Seismic Walkdown Checklist (SWC)

Equipment ID No. 1-1205-EG-002 Equip. Class¹² 21 (Tanks and Heat Exchangers)
 Equipment Description RHR HEAT EXCHANGER B
 Location: Bldg. AUX Floor El. 143'-6" Room, Area RC-91
 Manufacturer, Model, Etc. (optional but recommended) _____

Equipment ID No. 1-1208-46-153 Equip. Class¹² 0 (Other)

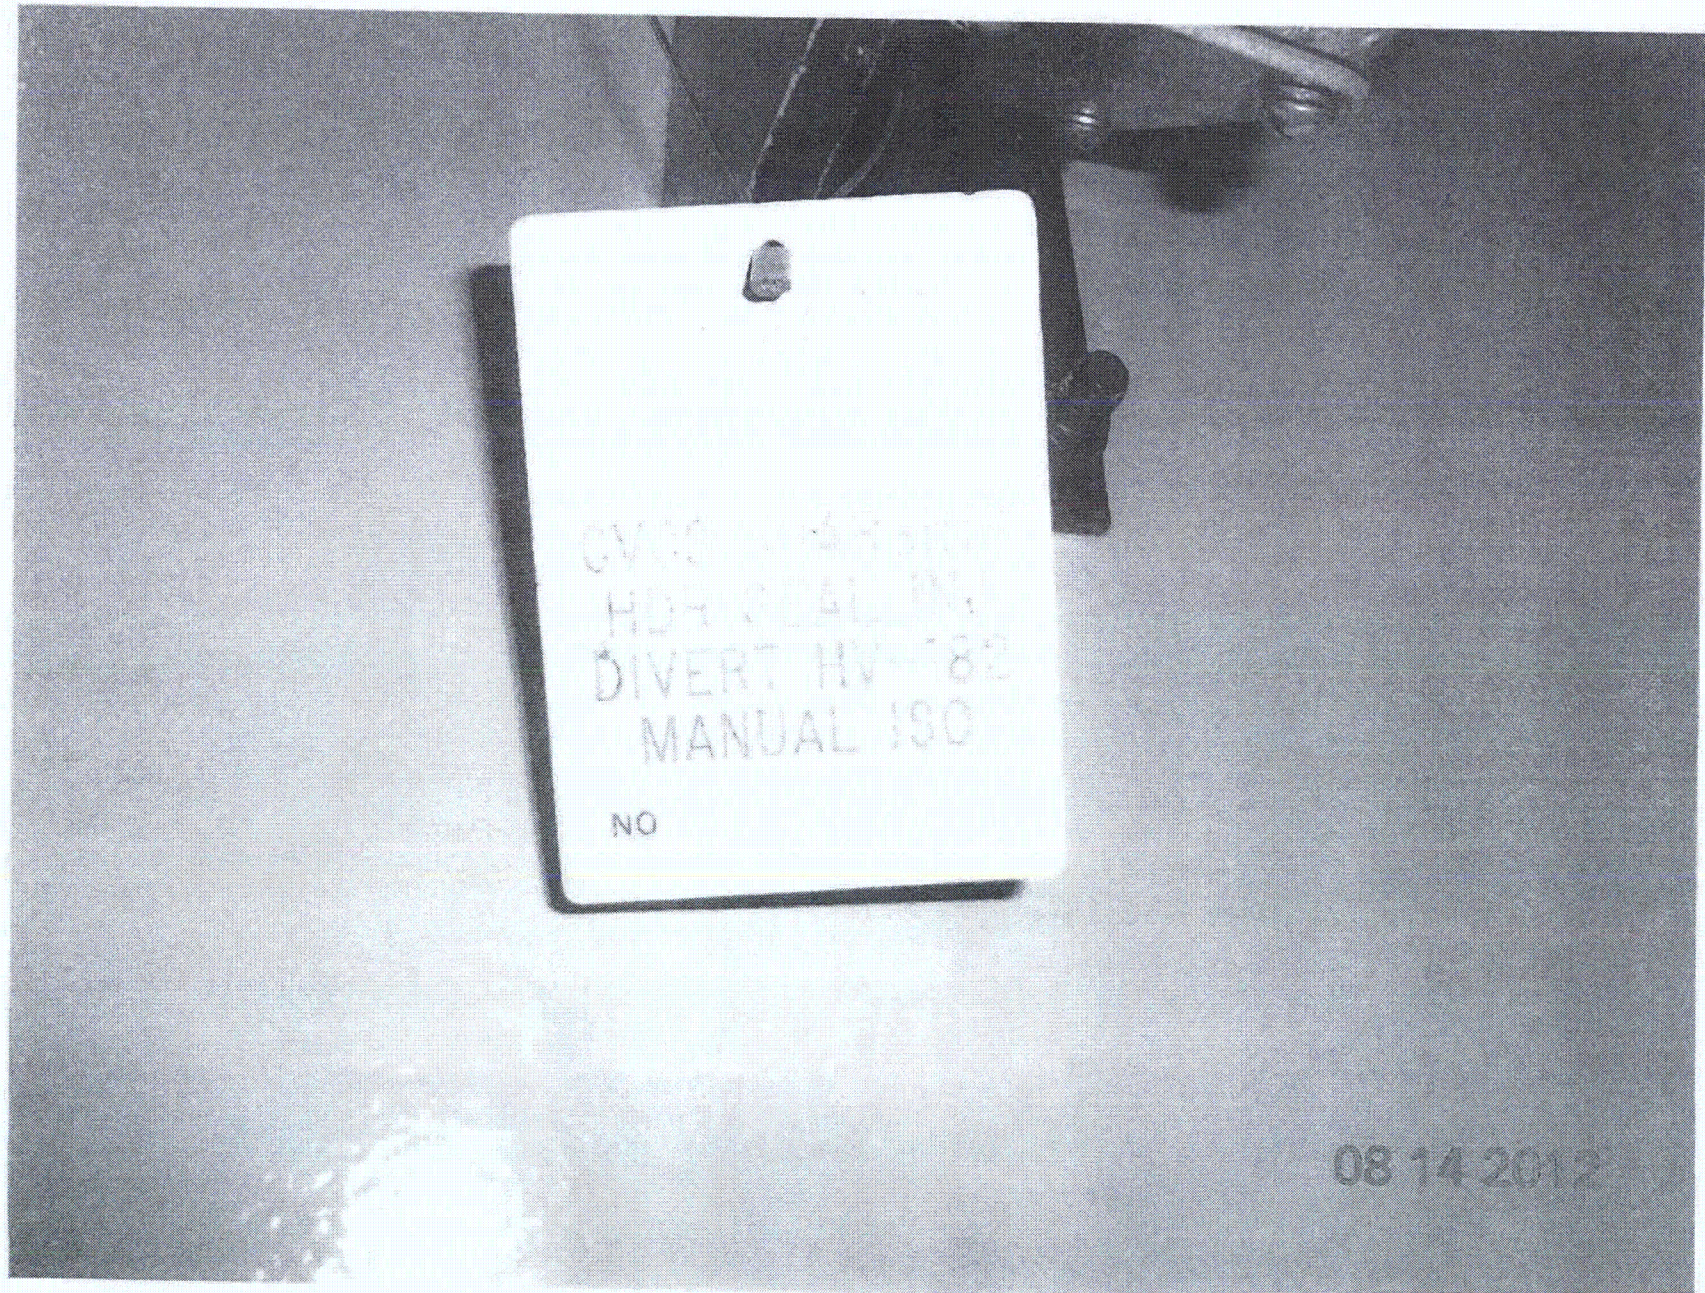
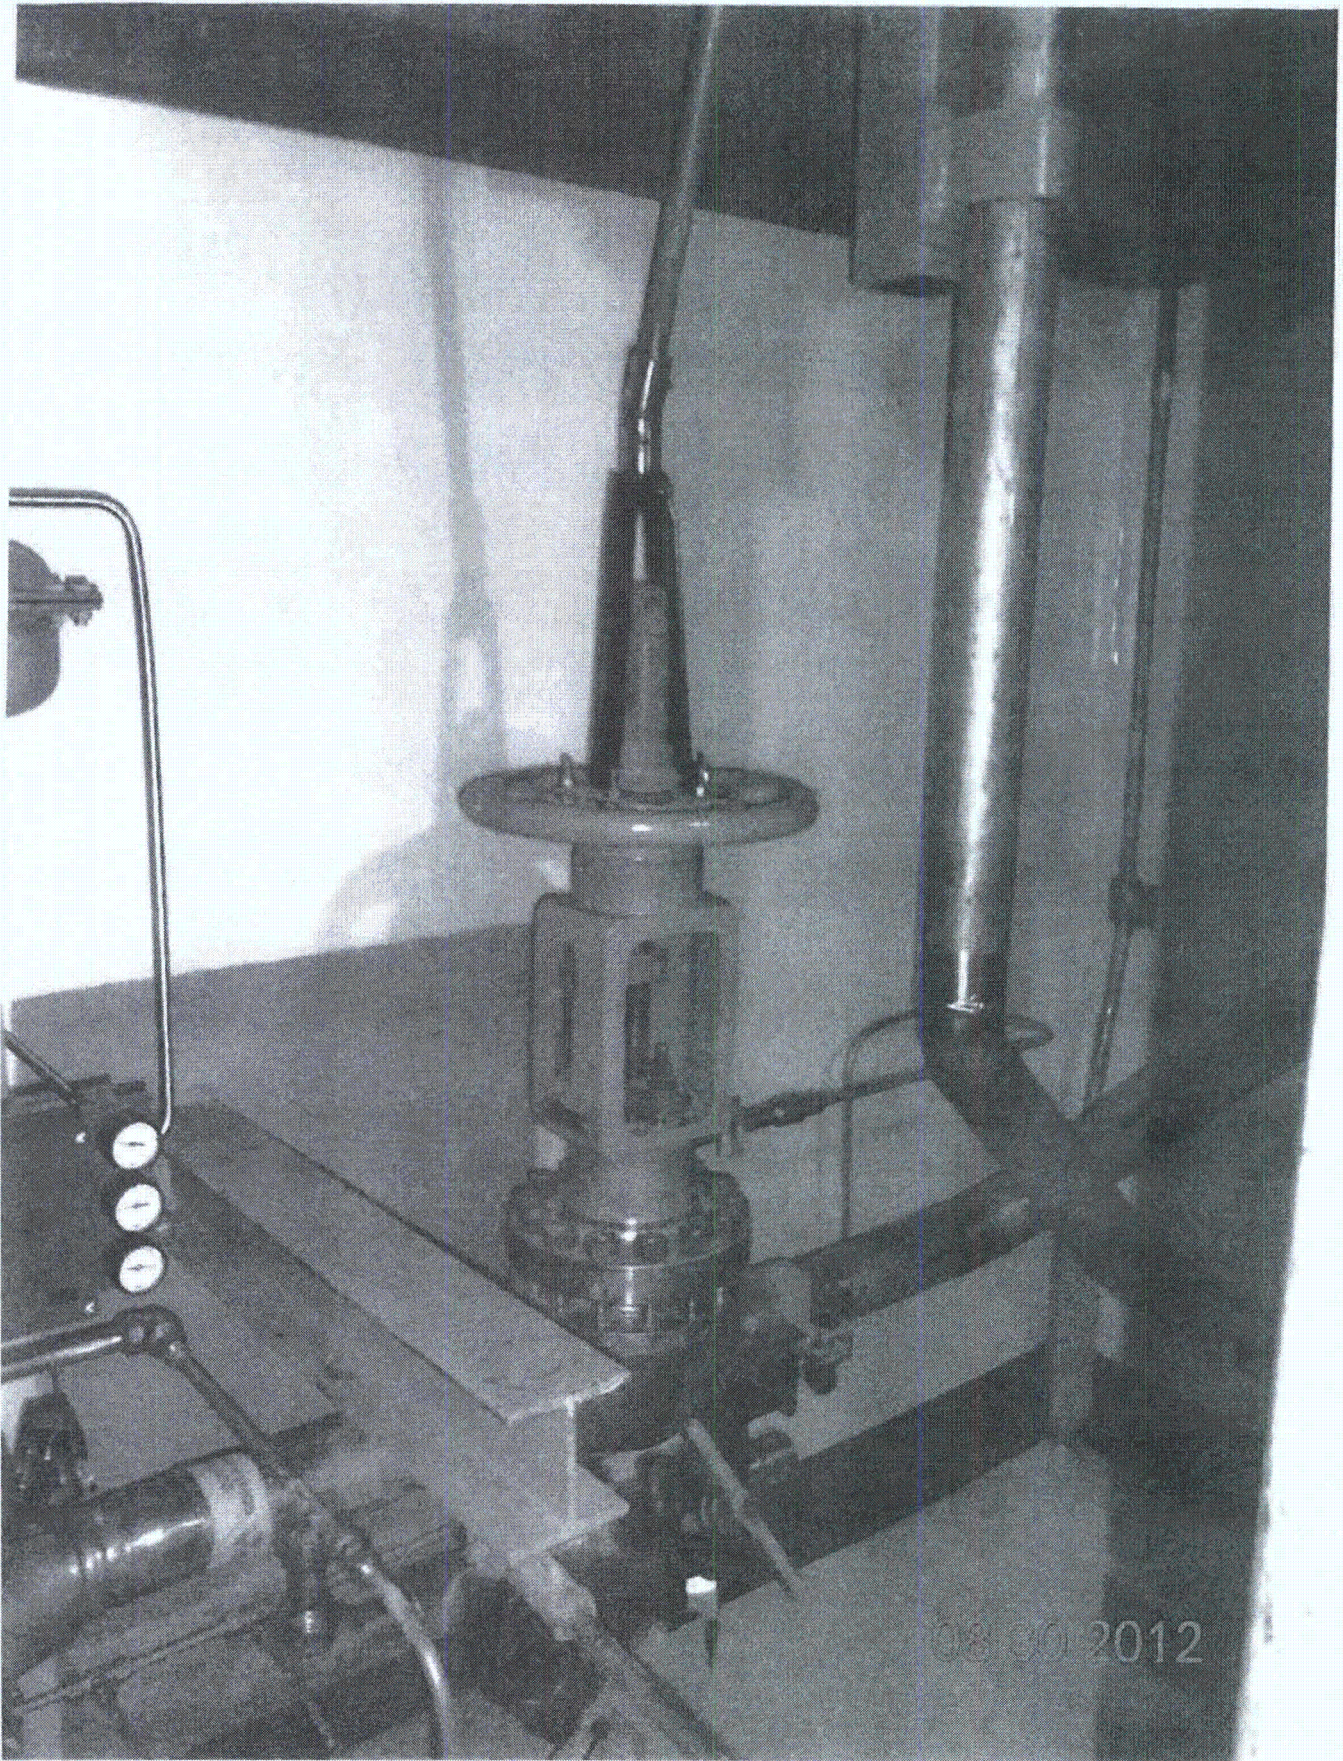
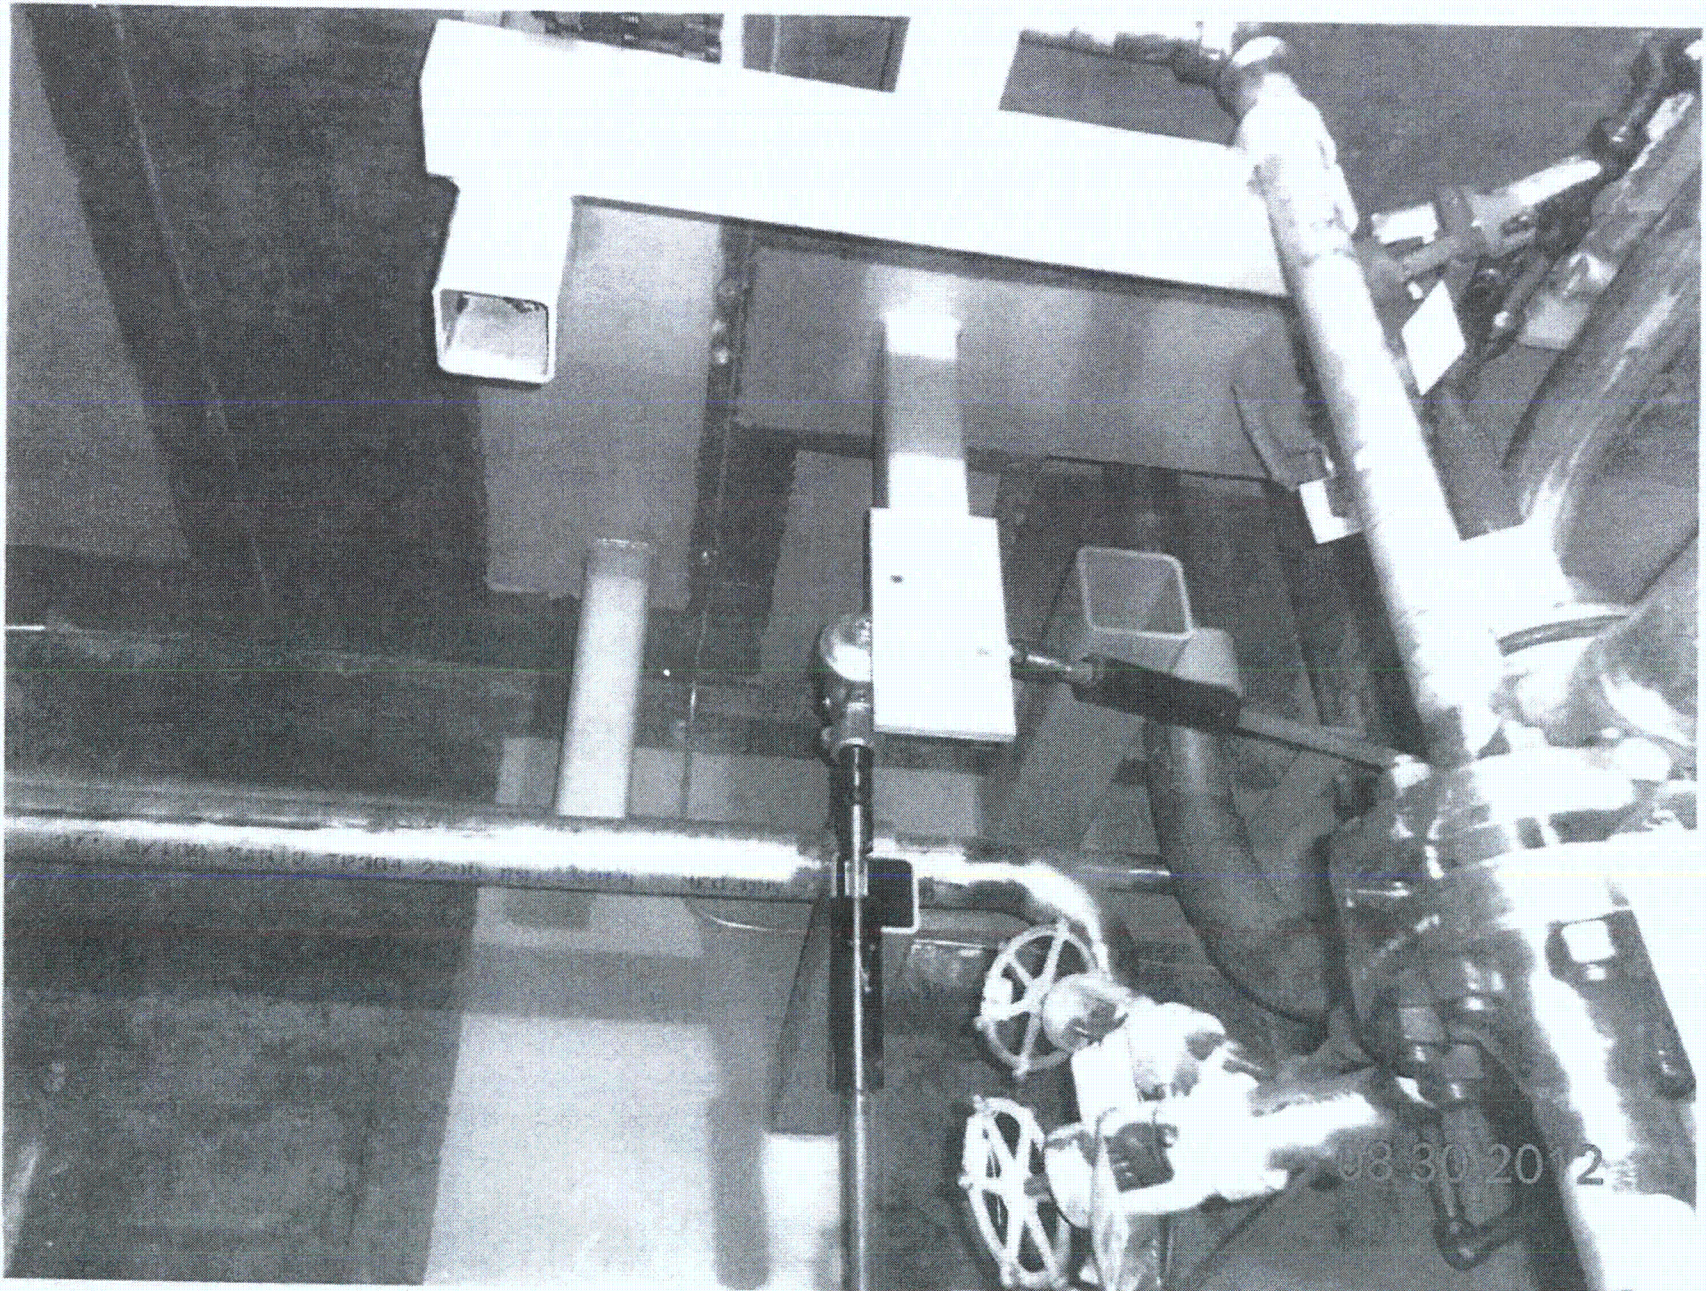
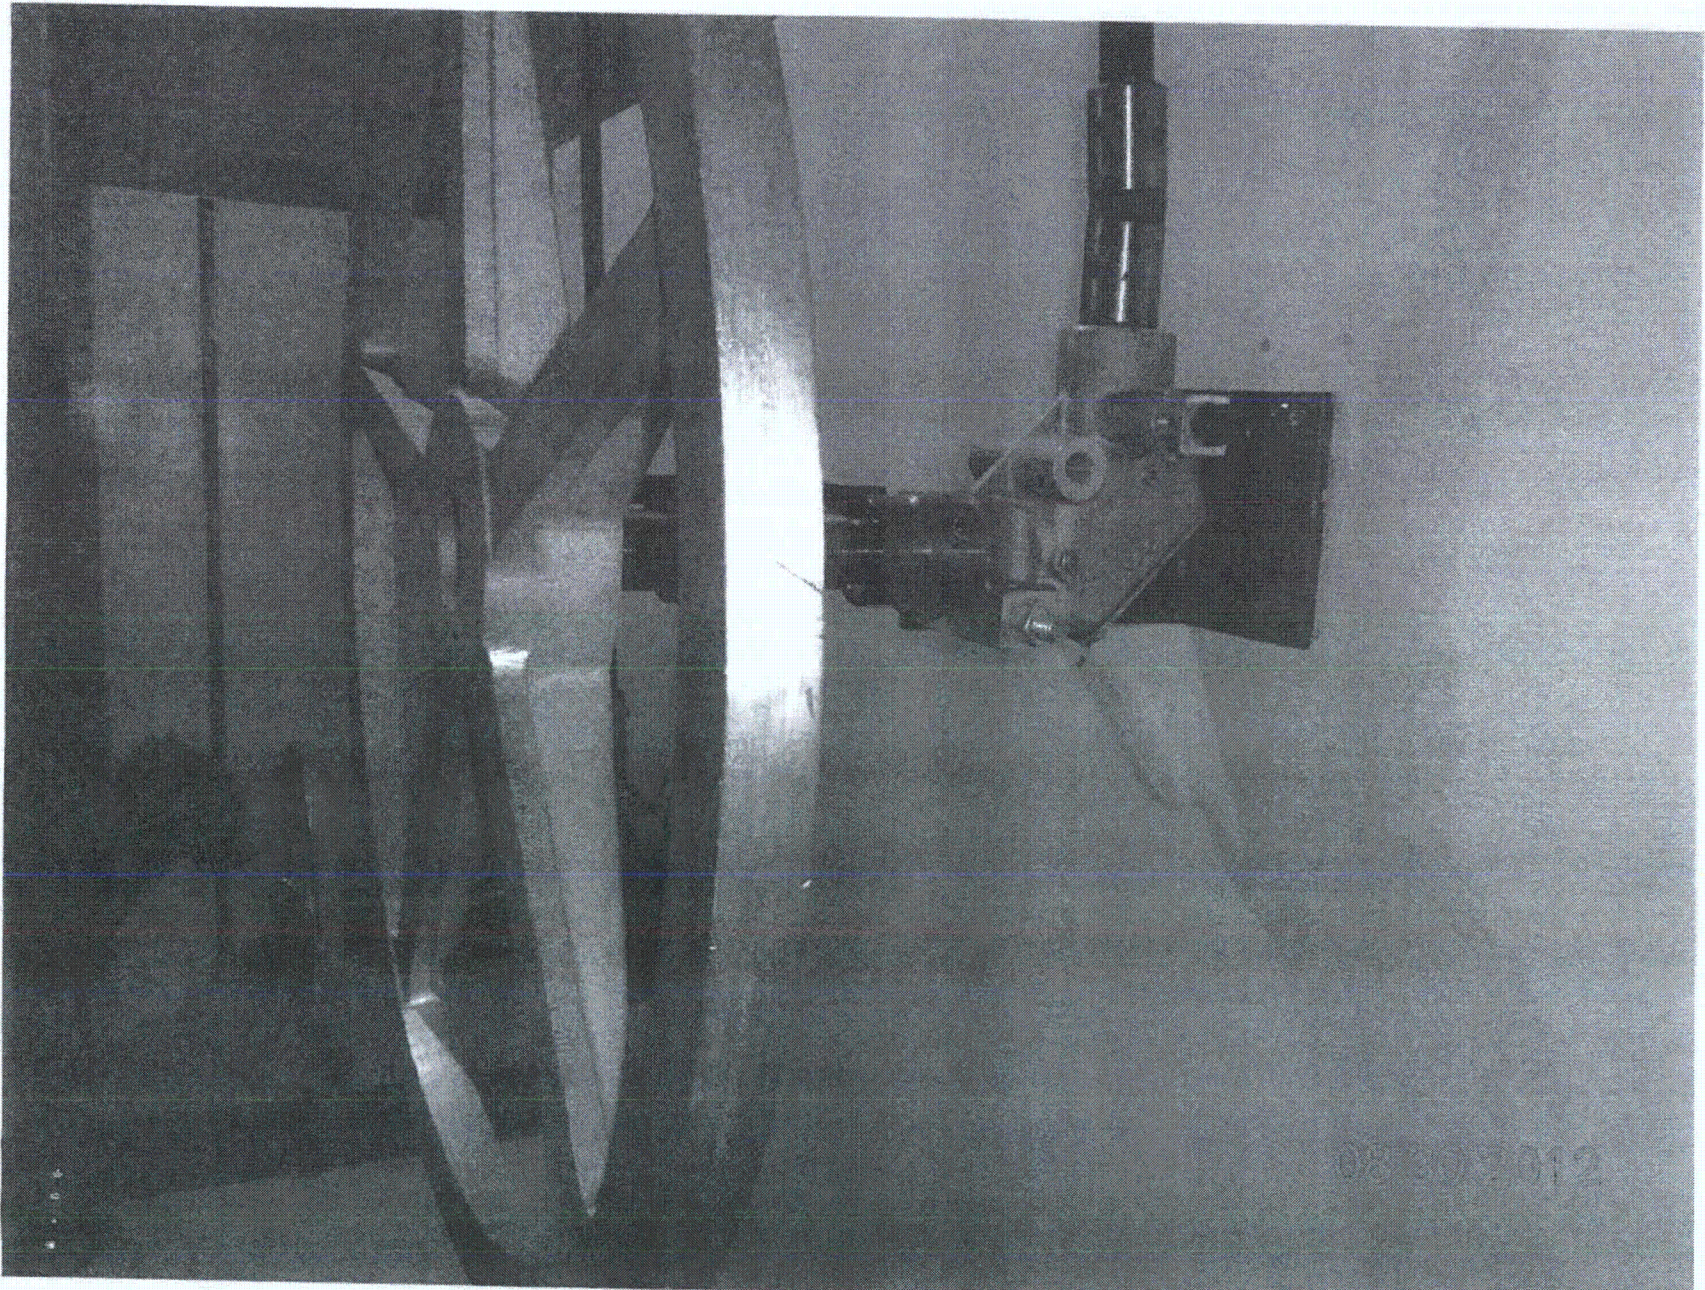
This component consists of the valve, a reach rod, and a handwheel for valve operation behind a shield wall. The handwheel support baseplate was reviewed for cracks near the anchors. The reach rod supports are welded to structural steel.
5. Is the anchorage configuration consistent with plant documentation? Y N U N/A

Review of the above anchorage questions is applicable to the welded supports (to structural steel) for the reach rod, and the handwheel support with anchored baseplate to the shield wall. The valve itself is a line-mounted item.

9. Do attached lines have adequate flexibility to avoid damage? Y N U N/A
Tubing attached to valve has adequate flexibility.
